Safety test of SpiderJack 3 produced in 2016

Rahden, 12. April 2017

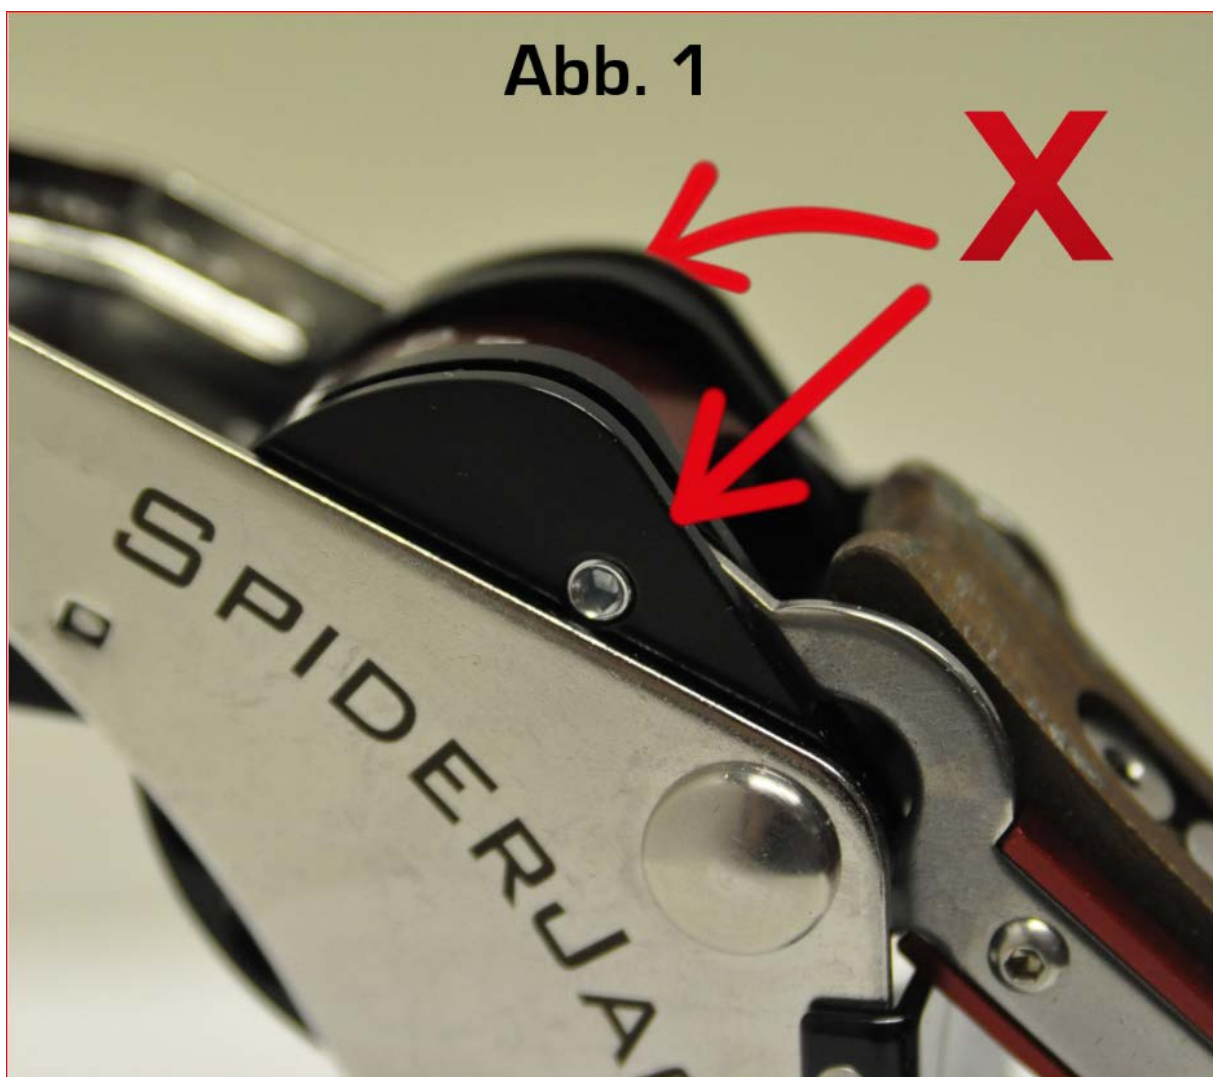
If the bonding of the grub screw to the thumb brake of SpiderJack 3 is defective, this can obstruct the movement of the friction clutch or the device body. In the worst case scenario, the device no longer grips the rope safely. After I had been informed that the clamping action was affected in this manner on a SpiderJack 3 with serial number: 25.16..., it is possible that more devices are affected. In the past, the bonding of the grub screw to the brake bearing has been safe and reliable in tests.

To discover whether there are more insufficiently bonded grub screws on SpiderJack 3, every user must check these *two screws* (Abb. 1).

Abb. 2

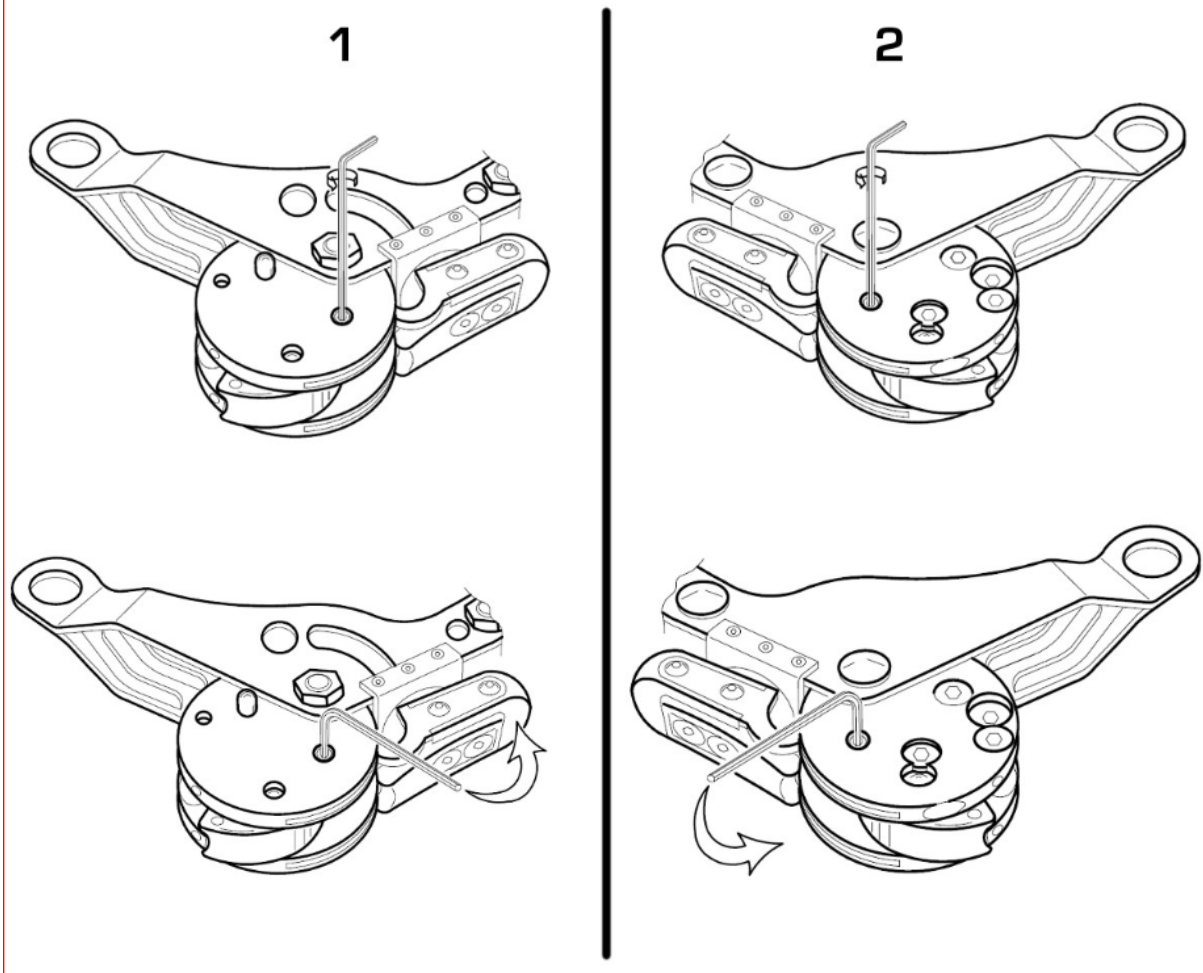
Therefore, every user of a SpiderJack 3, serial number: 25.16... is asked to carry out this check without delay based on the following instructions (Abb. 2).

For the test, please use the thinner hex driver (2.5 mm) that is supplied with SpiderJack 3. It is important that the hex driver is held on the short side, as shown (Abb. 2). If the user cannot turn the two grub screws with the method shown using normal force (1 to 1.5 Nm), everything is OK and the SpiderJack 3 is safe. It does not matter which direction the screw is turned. However, if one or both of the two grub screws can be turned, the SpiderJack 3 must not be used until the problem has been resolved. If the grub screws are not tight, contact us without delay. Naturally, we will send you a free repair kit with instructions immediately.

Abb. 3

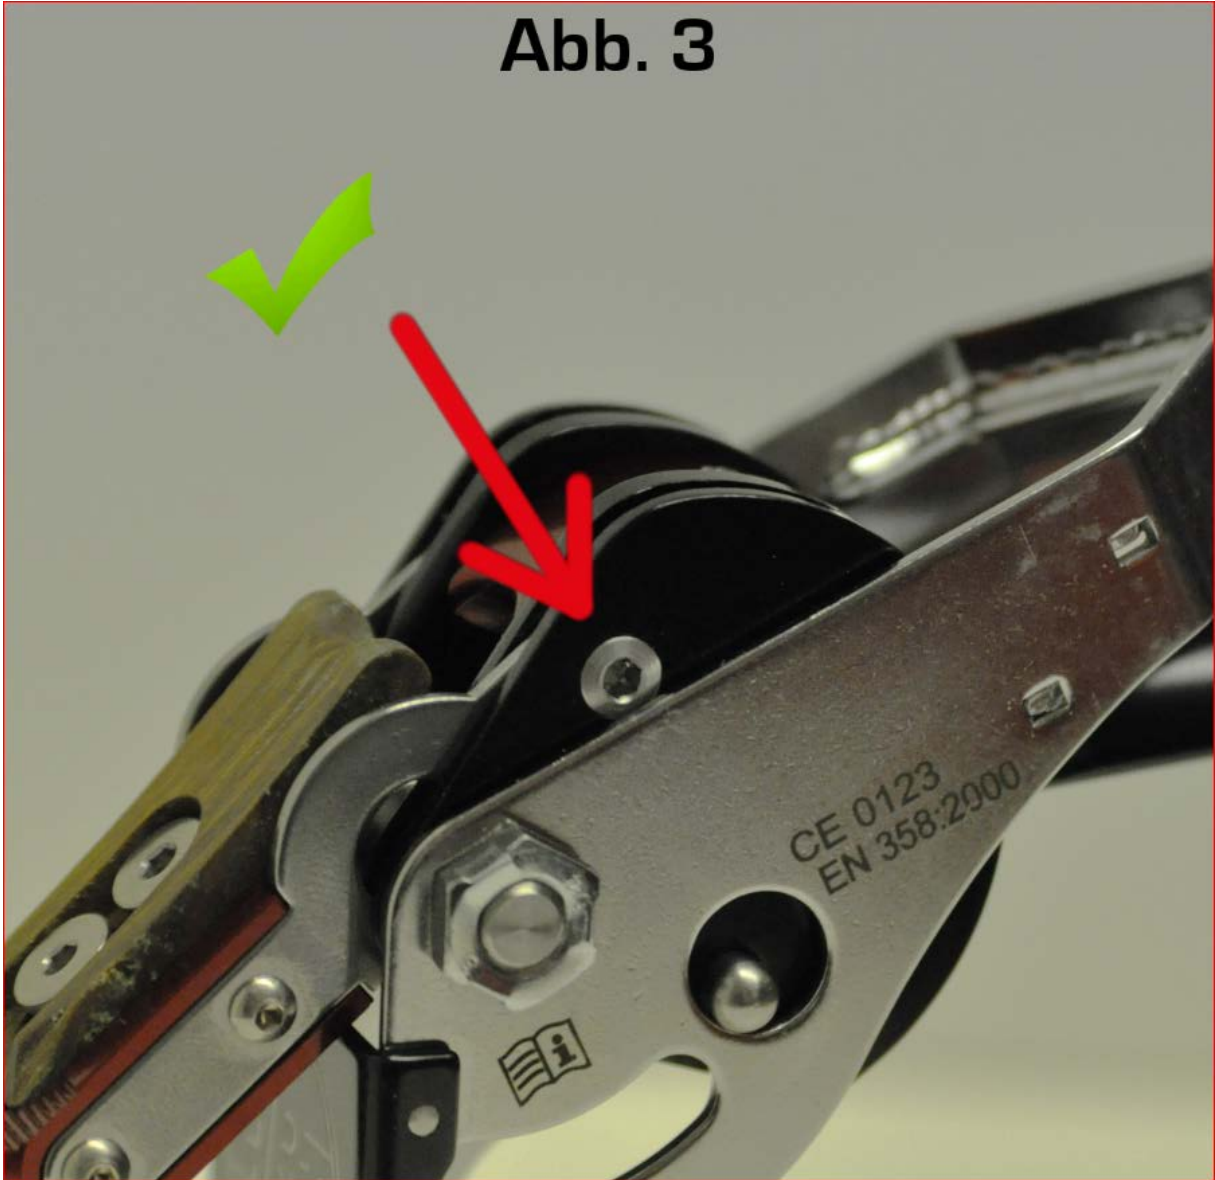
Owners of SpiderJack 3, serial numbers: 25.17... with the **new** grub screw (Abb. 3) do not have to carry out this safety test. The new grub screws with head are also mechanically fixed in place and proper bonding of every single screw is checked twice.
